Attachment G
Exceptions to Design Standards

Fact Sheet Exceptions to Mandatory Design Standards

LAUREN PROCTOR, Registered Civil Engineer
CH2M HILL

ATTACHMENT 2

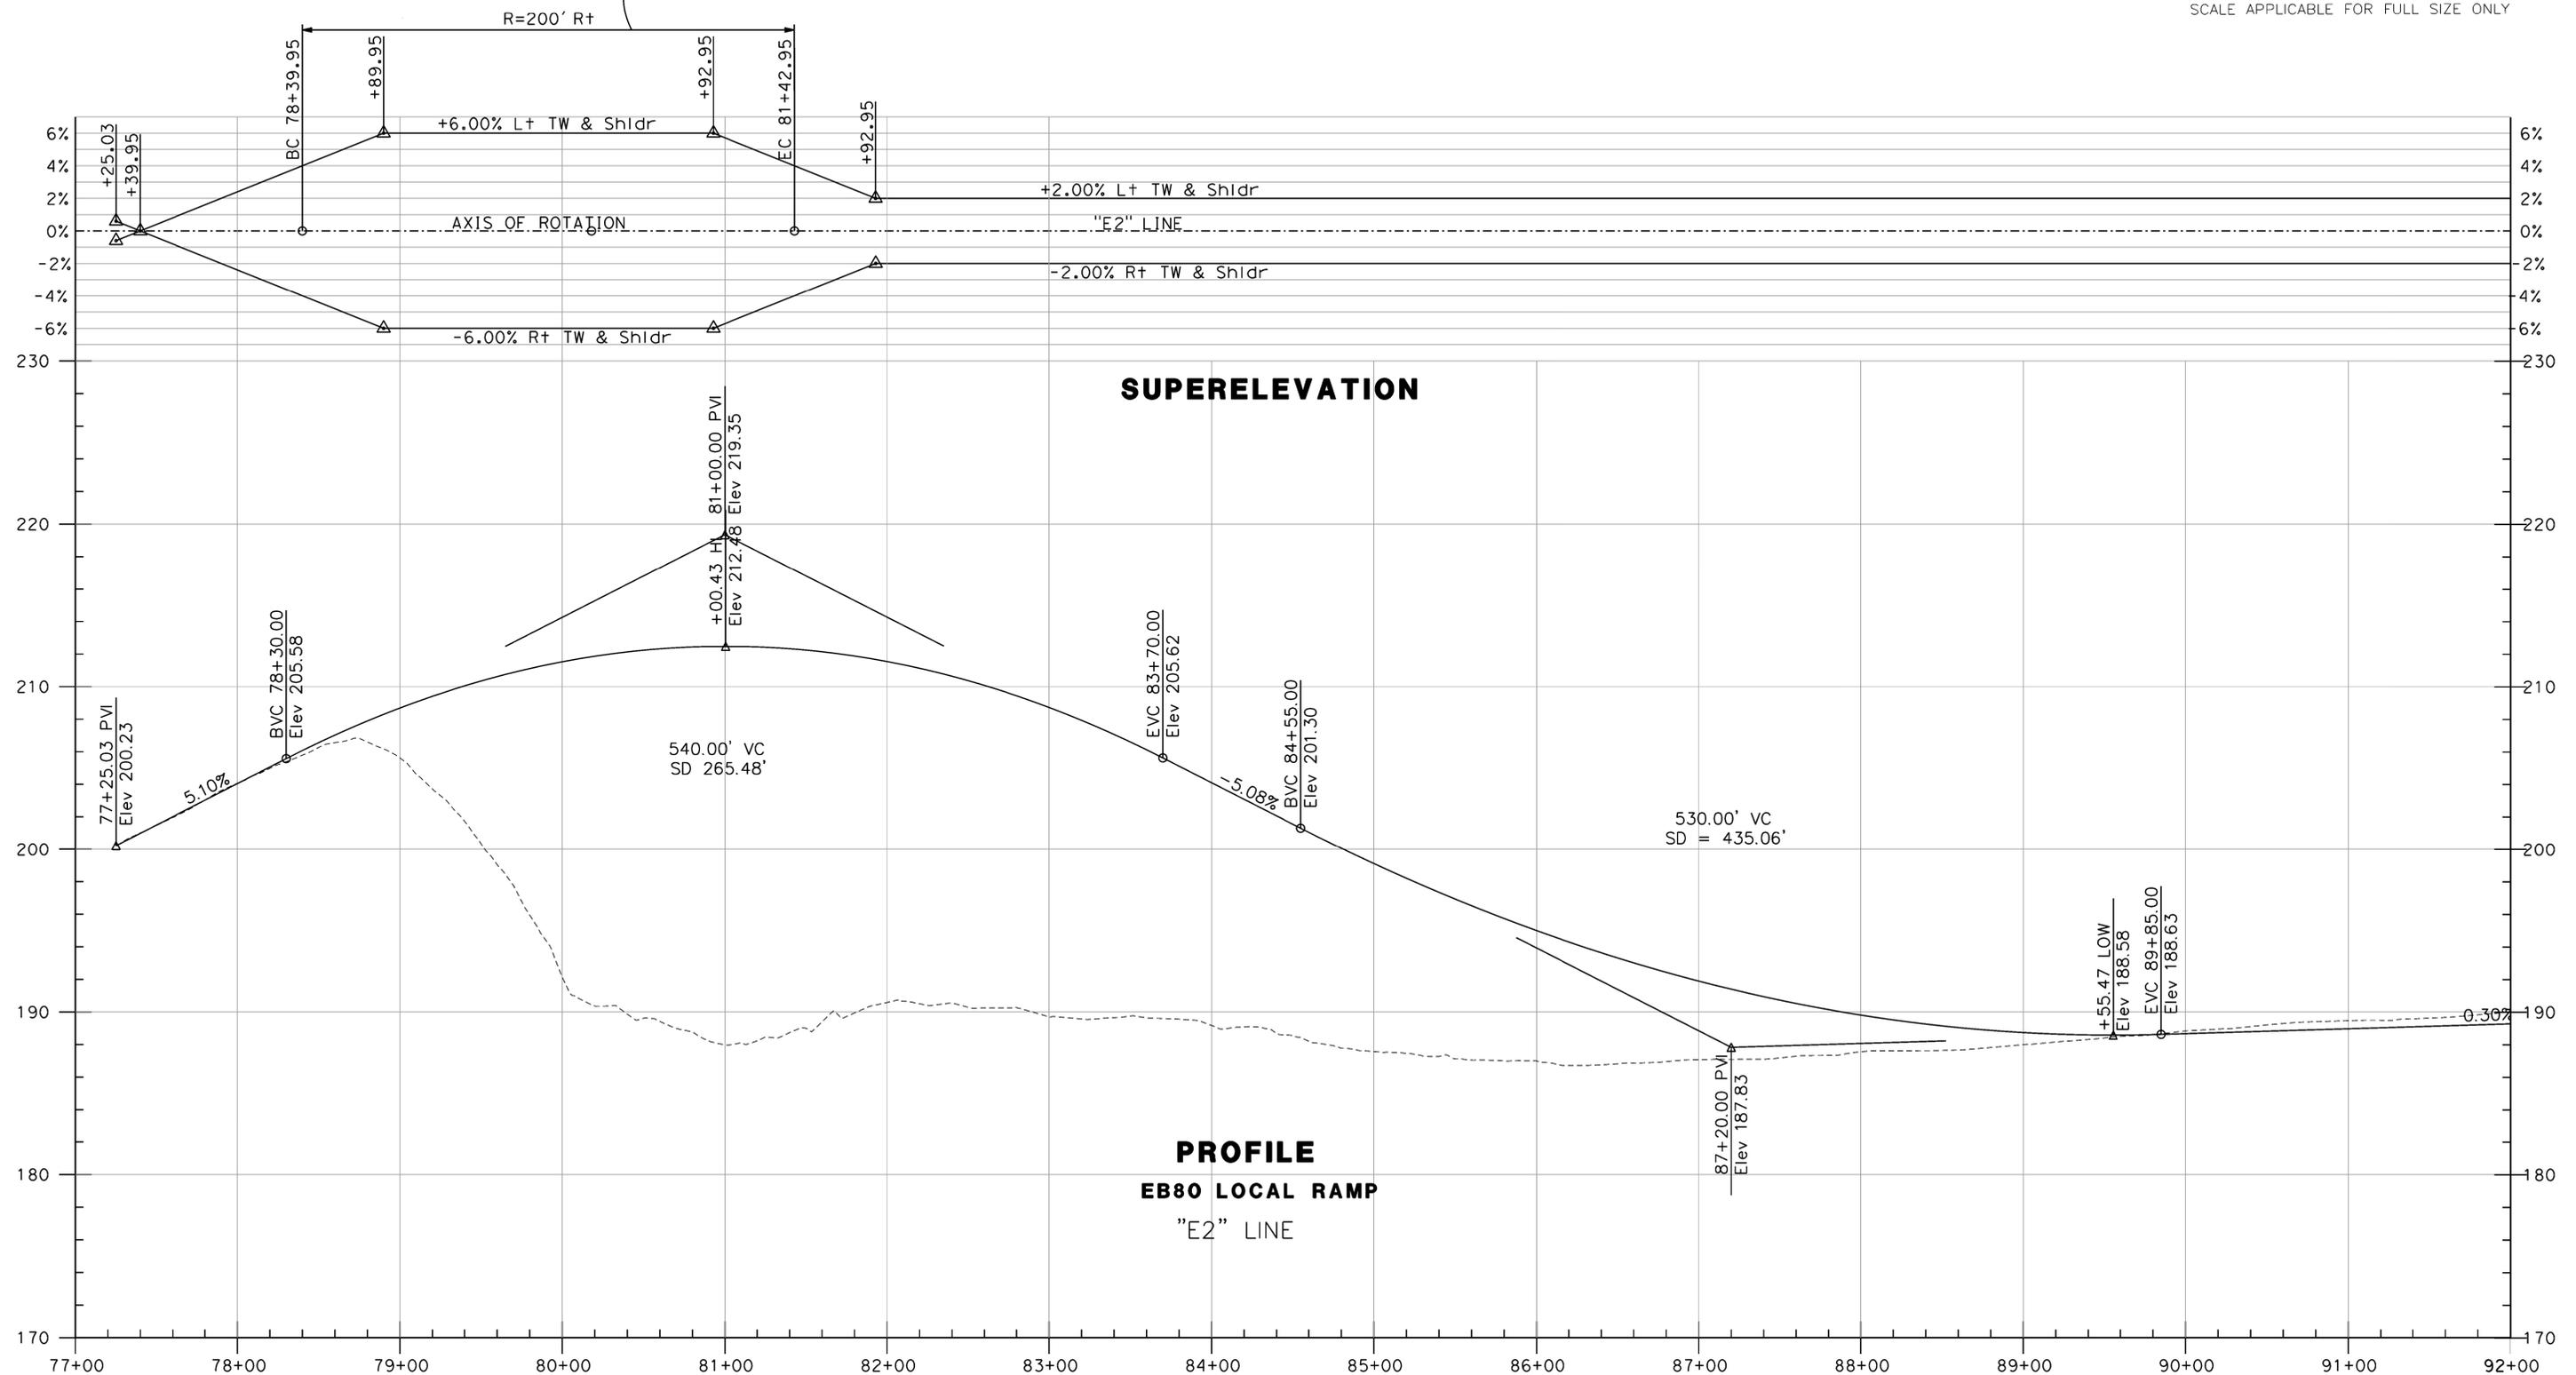
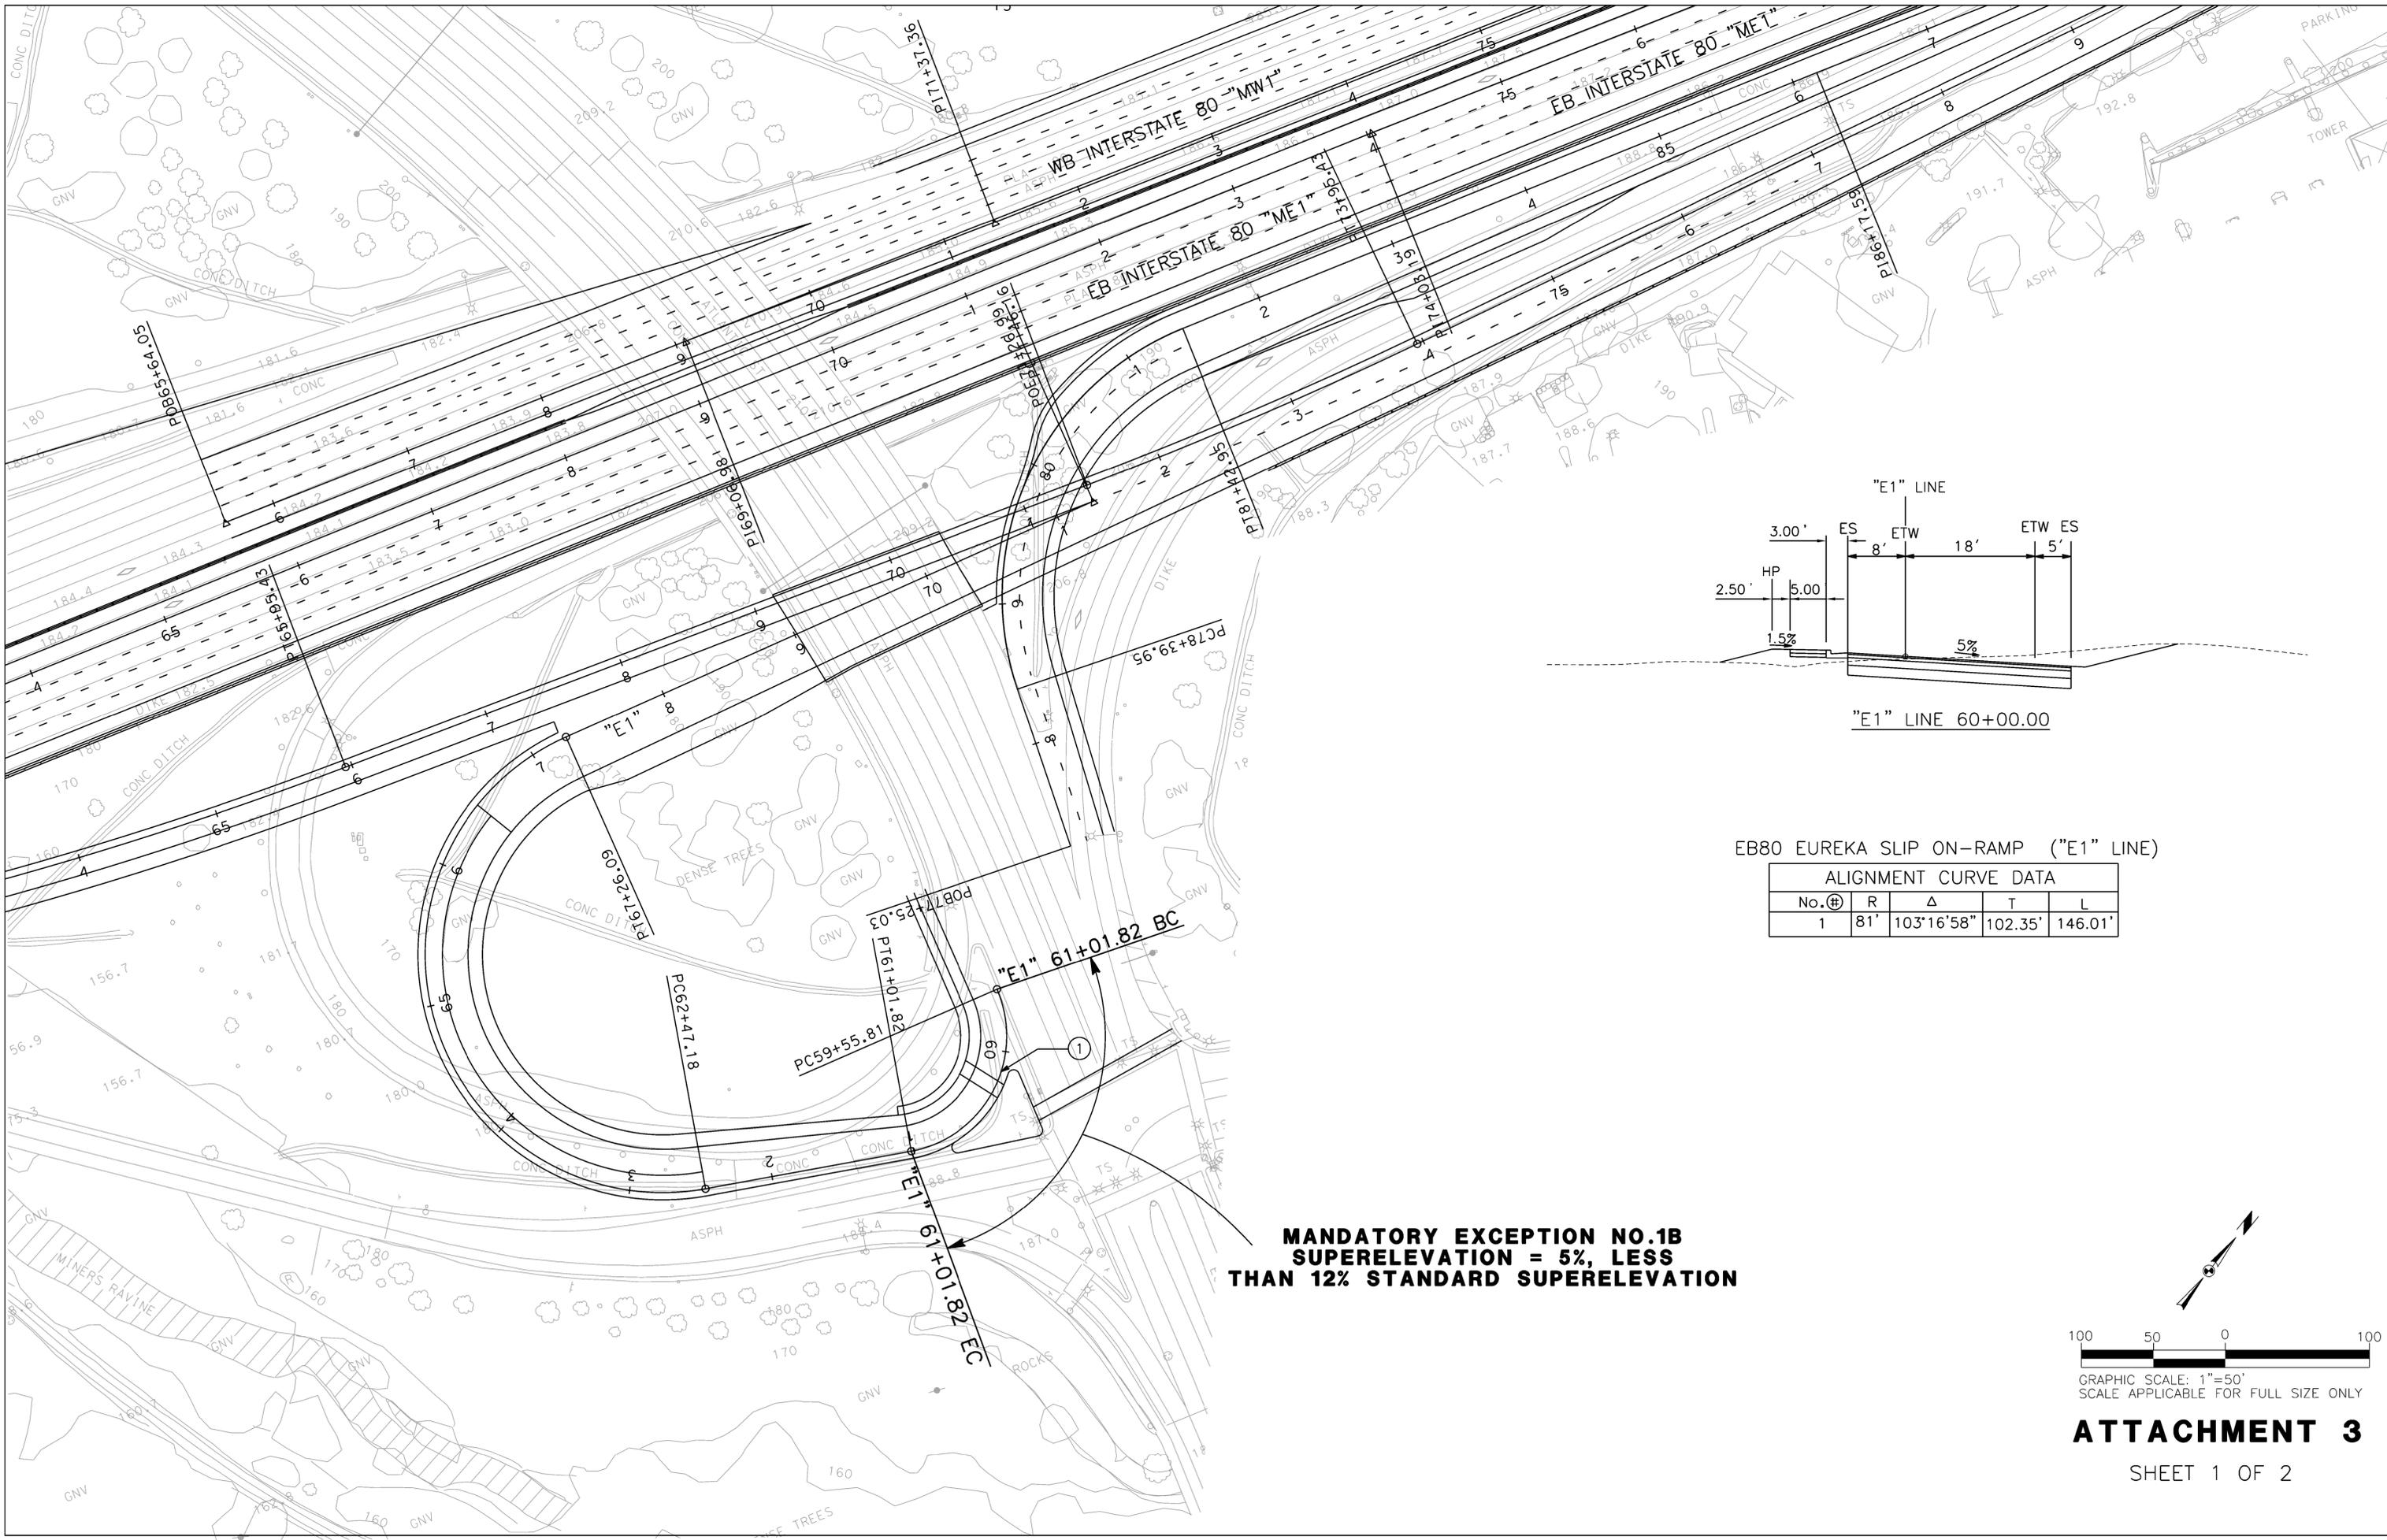
Location A: Eureka EB on-ramp, “E2” station 69+53.56 to 72+50.32, the proposed 200' curve will have superelevation rate of 6%. (See Attachment 2)

The standard superelevation required for 200' curve is 12%.

**MANDATORY EXCEPTION NO.1A
 SUPERELEVATION = 6%, LESS
 THAN 12% STANDARD SUPERELEVATION**

Location A: The reason for the design exception for location A is due to the existing Eureka Rd/Taylor Rd intersection and Eureka Rd 2% cross slope to the west. A higher superelevation rate would require an alignment with a longer tangent to accommodate superelevation runoff, which would shift the alignment further to the south and closer to the intersection. A 12% superelevation rate will also create a grade break of greater than 10% at the gore.

The proposed design with a non-standard feature will still meet the 25 mph design speed at the ramp terminus based on comfortable speed. The maximum comfortable speed based on the proposed design with 6% superelevation rate is 26 mph.

Conformance to standard would require relocating the Eureka Rd/Taylor Rd intersection to the south, realigning the EB off-ramp, impacting an environmental sensitive area, and acquiring new right of way.
